PARTS Bulletin

Parts Bulletin #2 June 2016

Subject: Return line for HF9000

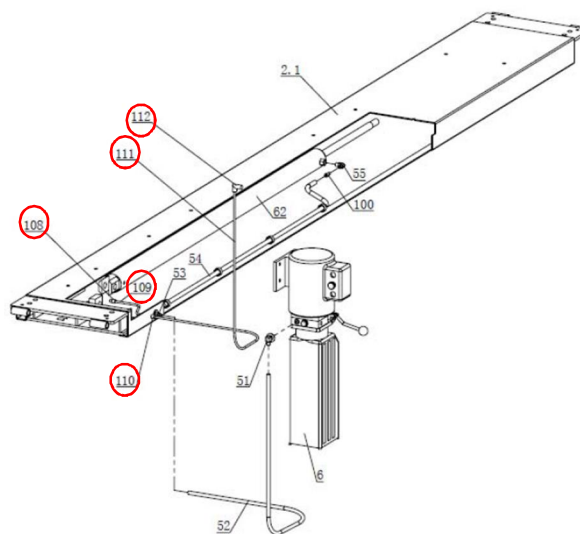
In order to solve the trouble caused by small leaking of the cylinder and to prolong the lifetime of the cylinder, we design the return line for HF9000.

For the lifts produced before 2015, if the cylinder failed, the lift will need the HF9000 feedback line kit to install the return line, But now only the lift with Power unit PDL4421 can install return line, PU JT-3-2.5 and JT-2-2.5H cannot be used to install return line.

Part number: 108, 109, 110, 111,112 are new added parts for the lift.

For the lifts produced after 2015, the parts needed are already packaged with the lift.
